**Submission to NSW Department of Planning and
Environment**

Improving Biodiversity Outcomes in the Ingleside Precinct

Pittwater Natural Heritage Association February 2017

Figure 4 Ecological Corridors Numbered

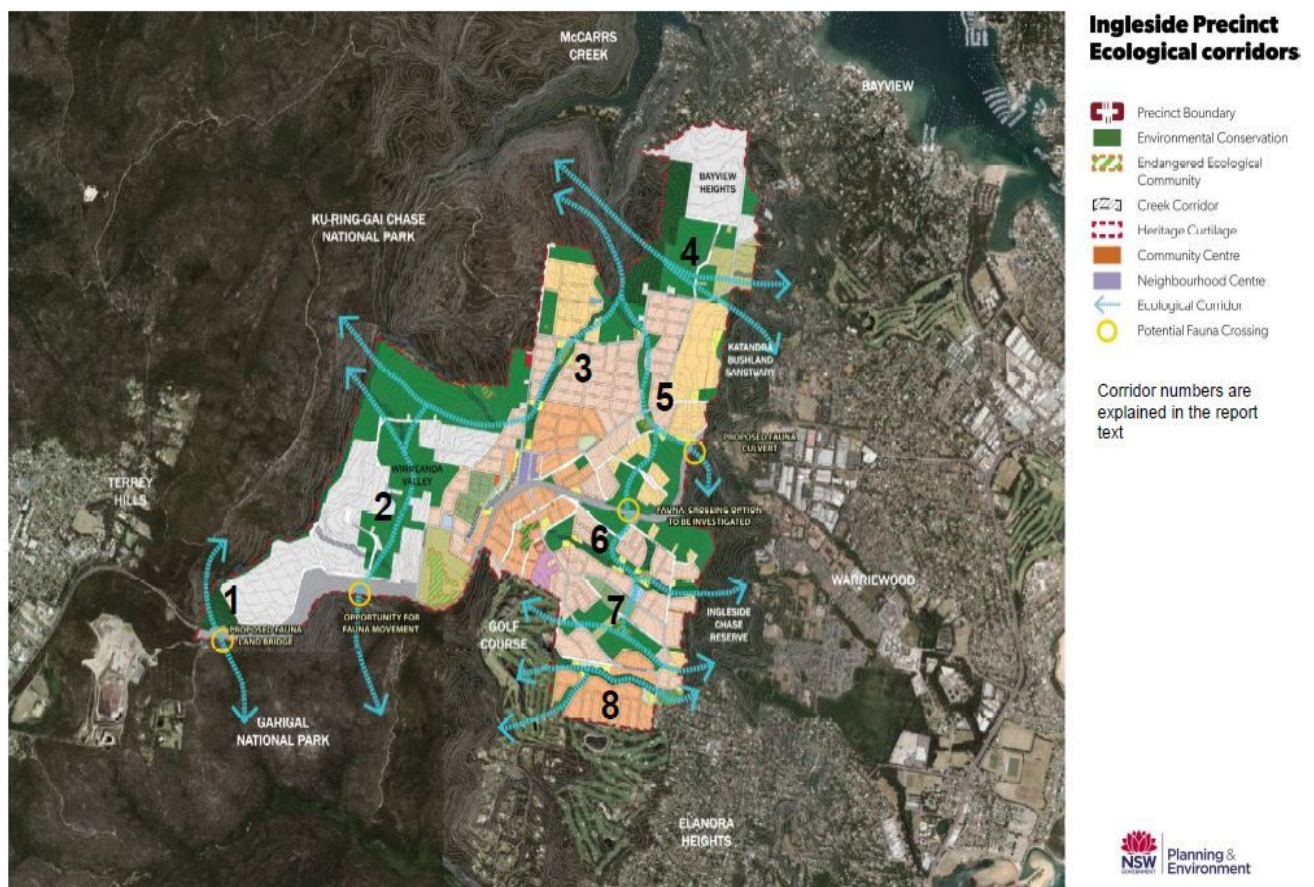
Corridor 7 has a number of limitations: Monash Golf Course sits at its western end, and the eastern end with two arms 26 metres and 29 metres wide it becomes too narrow to function effectively due to edge effects. These include weed invasion (already evident) and predation by domestic and feral cats and dogs. The proposed underpasses on Ingleside and Powderworks Roads will be critical for its effectiveness. As it contains valuable heathland and is a known habitat of the Eastern Pygmy Possum (an endangered species) we believe it must be effectively linked to Ingleside Chase reserve.

Recommendation 9: That the two narrow arms at the eastern end of corridor 7 as shown in the Draft Structure Plan for ecological corridors (see figure 4) be replaced by a single corridor of at least 100 metres in width.

Figure 5 Vegetated link required between Corridor 5 and Katandra (Blue arrow)

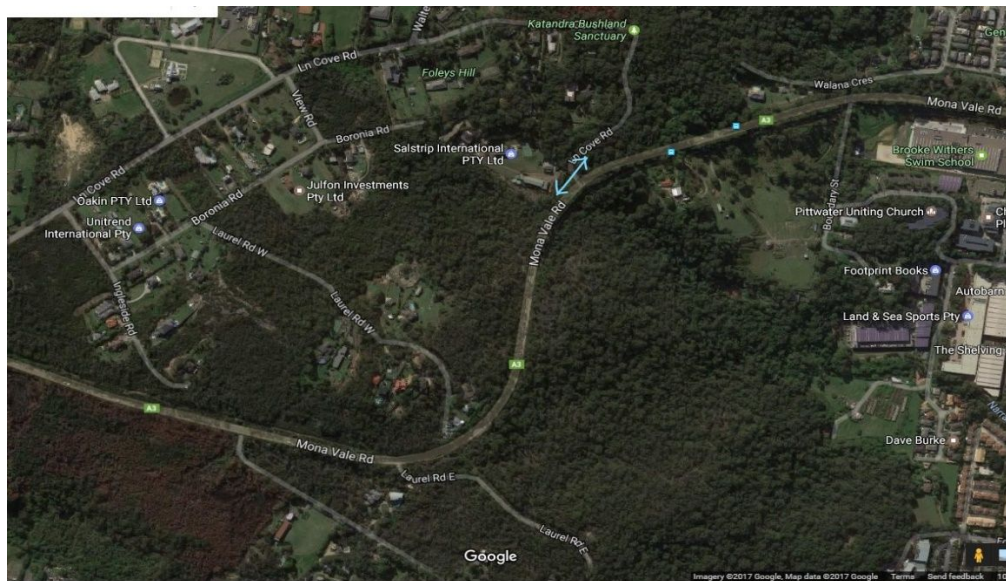
The benefits of this corridor would be enhanced if it were linked with Katandra Bushland Sanctuary as shown in Figure 3. At present the only fauna corridor linking Katandra to Ku-ring-gai Chase National Park is corridor 4, which we consider to be less than ideal. In any case one corridor to this important reserve is not sufficient, and it needs to be linked to Ingleside Chase Reserve.

Recommendation 7: That a vegetated corridor be created between Katandra Bushland Sanctuary and Corridor 5.

Figure 6. Extension of Corridor 6 to link with Garigal National Park

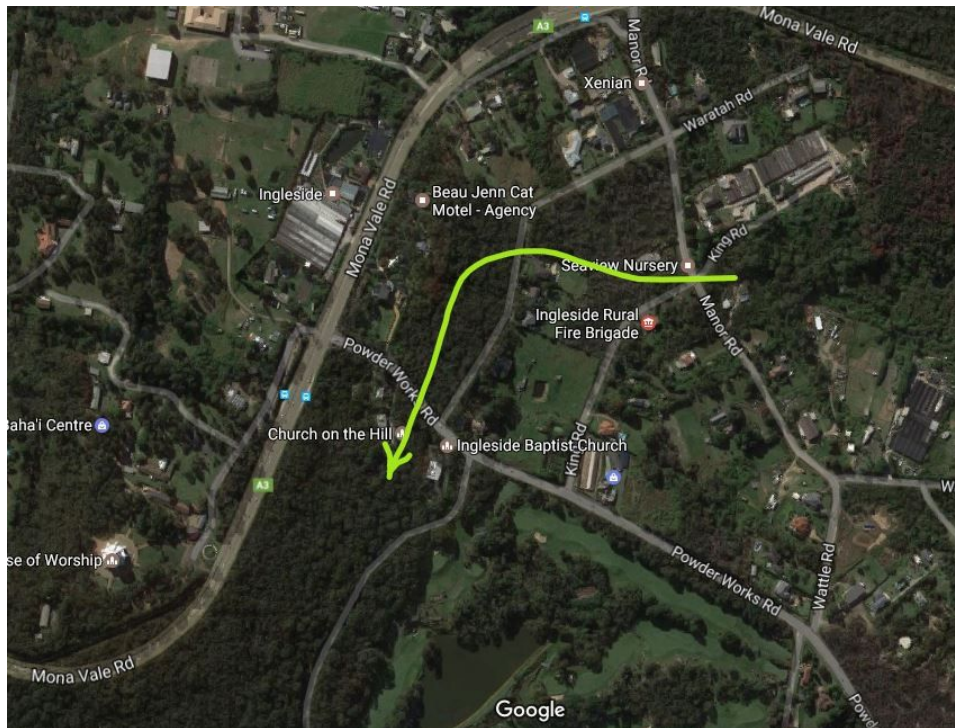
Corridor 6 extends into the Ingleside precinct along the north arm of Mullet Creek. We note that Eco Logical Australia states (p 85) that “it does not extend as far west as the recommended wildlife corridor.” This corridor should be extended to link with the Coastal Upland Swamp to the north and what we consider to be a related upland swamp/wet heath area to the north-west between Waratah and Mona Vale Roads then on to link with Garigal National Park.

Recommendation 8: That corridor 6 be extended to make an effective fauna link between Ingleside Chase reserve and Garigal National Park

Figure 8 Land suitable for E3 Environmental Management zoning

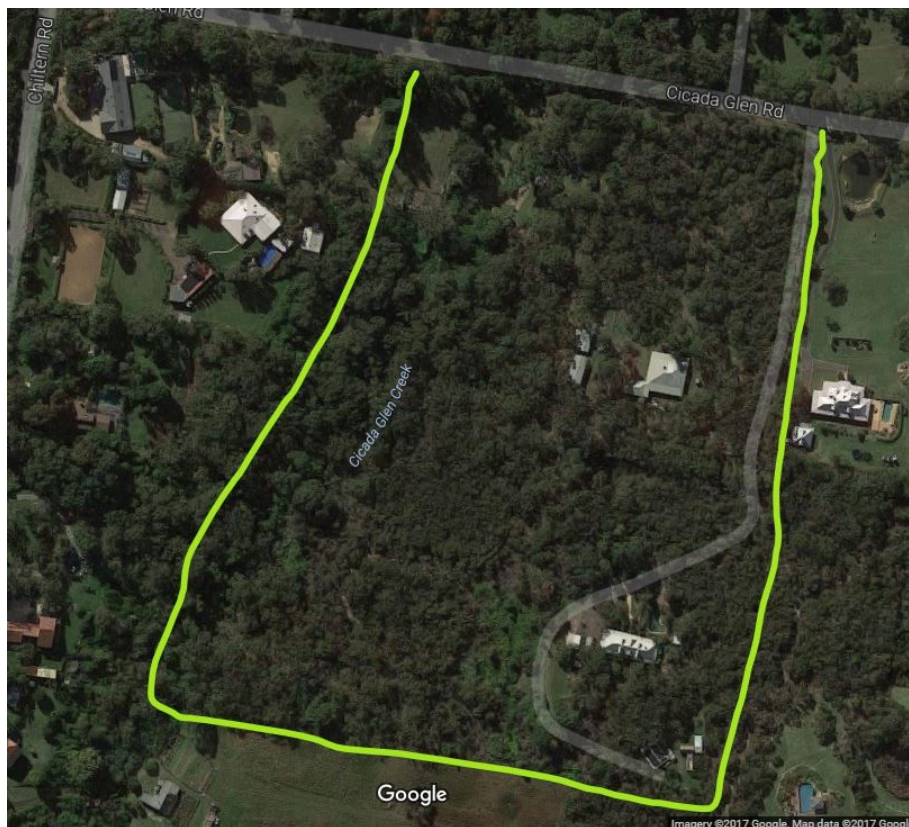
One area within the precinct that should be preserved as an urban forest is that bushland area on the eastern side of Cicada Glen Creek, which fronts Cicada Glen Road (Figure 4).

Recommendation 13: That this land should be zoned E3, Environmental Management and biobanked to provide biodiversity offsets within the Ingleside Precinct.
